ML395/ML3410/PM3410 series Maintenance Combination list

Combination List

Point of view of new part and old part

1) Printer Out side (Printing of Label)

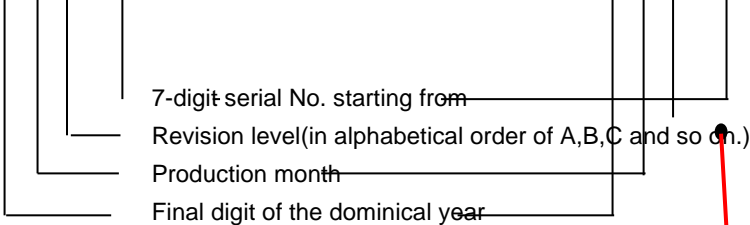
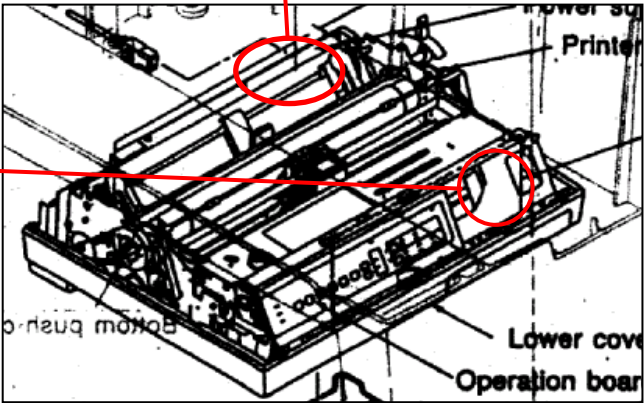
Terminal Thickness 0.5mm type

2 05 A 1234567

Mark accompaniment be correspondence 0.3 mm

Terminal Thickness 0.3mm type

2 06 B 4000001

(The number of the head is 4.)

1) Main PCB

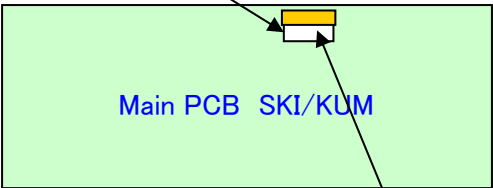
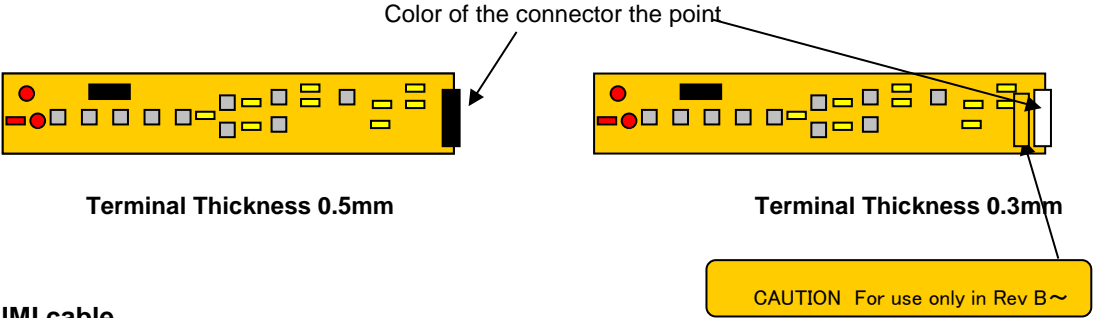
Terminal Thickness 0.5mm

Color of the connector the point

Terminal Thickness 0.3mm

CAUTION For use only in Rev B~
